Job Code:	M920034 – 26-007	Product:	Lineage LVT1
Date:	5/20/2026	Repair Time:	0.2

This bulletin describes the procedure to connect the 12-volt side of the water heater using harness EL-2031 (410536) on affected Lineage units.

Fig. 2 — Red wire spade connector installed at the next empty 12-volt DP location.

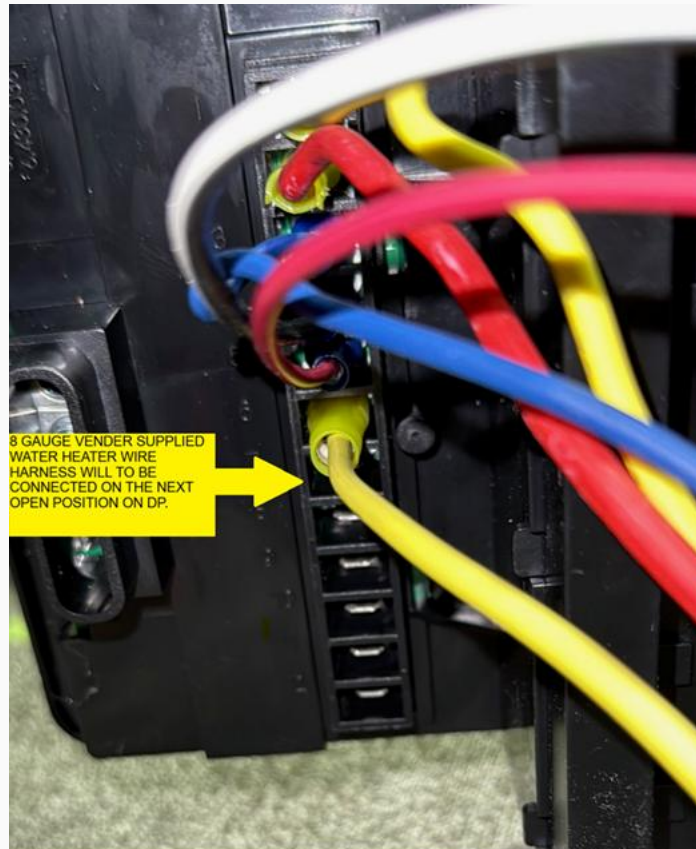
Step 3 — Connect the spade connector on the red wire to the next empty spot on the 12-volt distribution panel.
